TECHNICAL BULLETIN

ELECTRONICS DIVISION
DOCUMENT NR Ø35-643

POKER PLUS and FAIR FIGHT

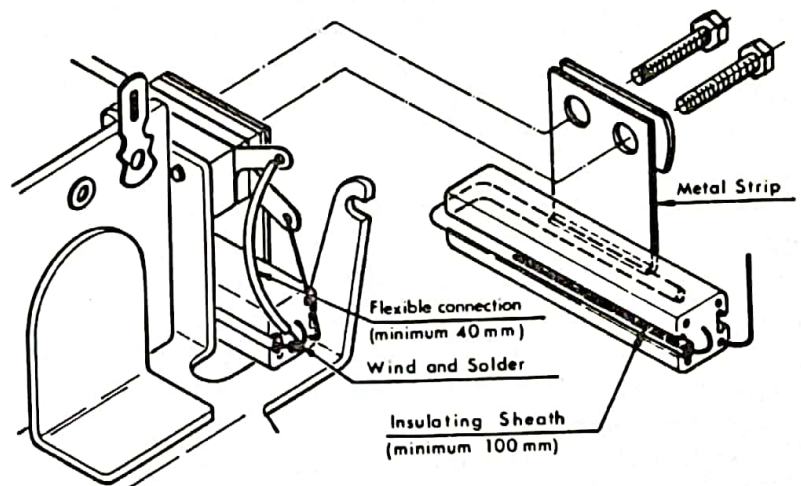
The right or left hand flipper vibrates when activated, because the centre terminal of the relevant 22 ohm resistor has been broken off.

As a result of the logical vibration created by the flipper assembly, and together with the thermal dissipation produced in the resistor, one of the terminals (normally the centre one) is broken or becomes faulty in its internal contact, producing the trouble referred to above. By incorporating the metal strip as shown on the figure we can drastically reduce the vibrations on the resistor, and by joining up the centre terminal by means of a flexible connection, we have completely eliminated any possible recurrence of this problem.

Replace the resistor connecting it exactly as shown on the figure below.

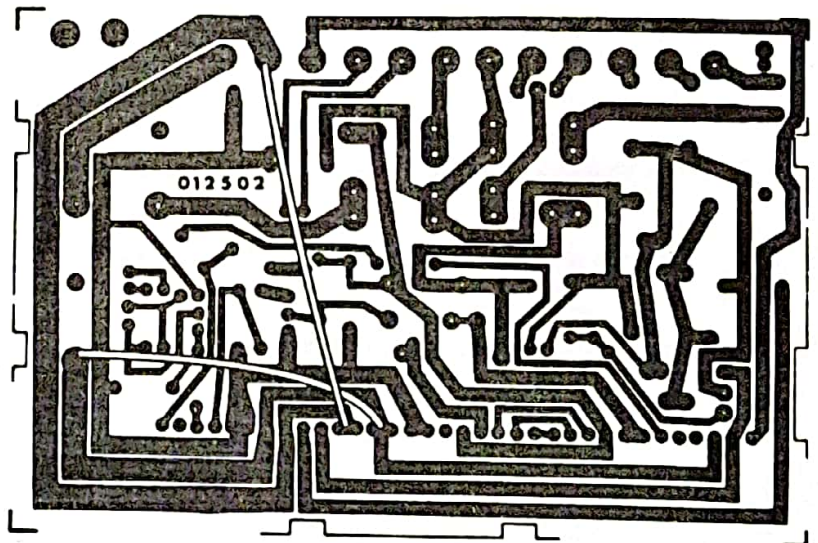
The right hand side of the Power Supply printed circuit board, can become considerably overheated and as a result you might experience a burning out of some contacts on the connector or the 6.3 volt tracks.

The stable illumination current (6.3 volts AC) heats the tracks by virtue of the Joule effect, and this heat is transferred to the pins on the connector, which deteriorates in turn the nylon supporting these pins.

Take out the circuit board, replace where necessary the connector if it has been damaged, and cable up the bridges exactly as shown in the figure below, between the points indicated.
